Office Action Summary

09/367,153

SIBBALD ET AL.

Fig.8.

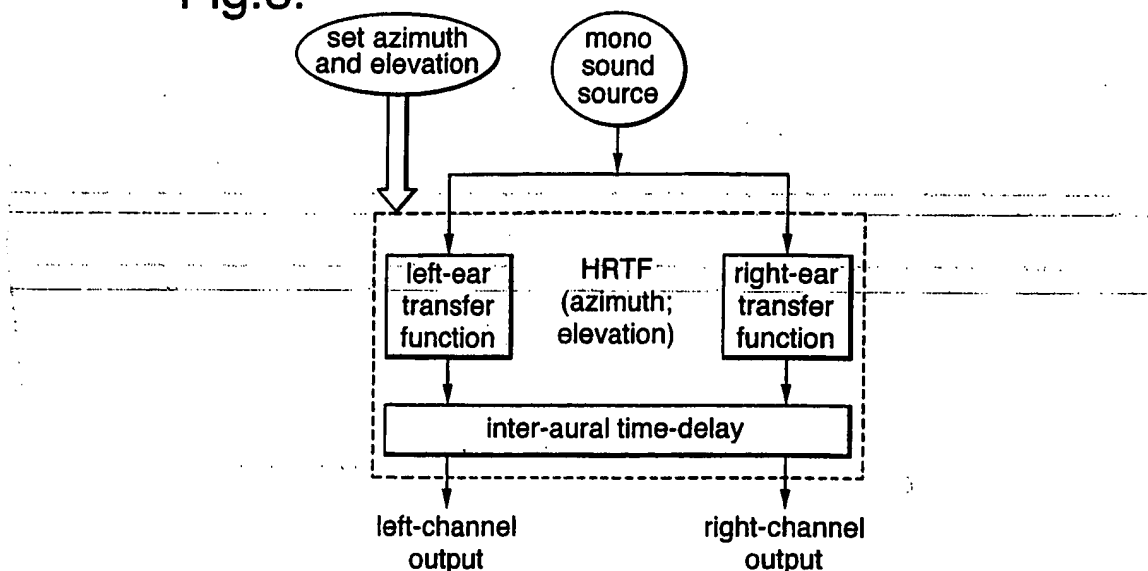
3. Claims 14 is rejected under 35 U.S.C. 103(a) as being unpatentable over applicant's admitted prior art (page 2, line 23; Figure 8).

Regarding claim 14, the applicant's admitted prior art discloses a prior art method of processing an audio signal.

It teaches of left and right channel output signals created from a mono sound source, which reads on “providing a right channel and left channel, each of said right channel and left channel carrying said single channel audio signal”; both the left and right channel processed using HRTF on each channel separately which reads on “modifying said single channel audio signal of each of said right channel and said left channel using at least one of a plurality of head response transfer functions to provide a right signal in said right channel for a right ear of said listener and a left signal in said left channel for a left ear of said listener”; both the right and left signals are delayed which reads on “introducing a time delay between said right channel and said left channel to provide cues to perception of a direction of said source position relative to said preferred position of said listener at a given time, and said time delay corresponding to an interaural time difference of said sound from sound source with respect to said listener”. The interaural time difference describes the time delay between sounds arriving at the left and right ears. It is well known in the art that interaural time difference is a source of localization cues. It is obvious that you would use the respective values of magnitude of the left and right signal to provide cues for perception of the source position from the preferred position at said given time because the goal is to achieve the best possible and most accurate sound. Thus it would have been obvious to one of ordinary skill at the time of the invention to use the applicant’s prior art in order to process a single channel audio signal using binaural processing in order to achieve the best sound.
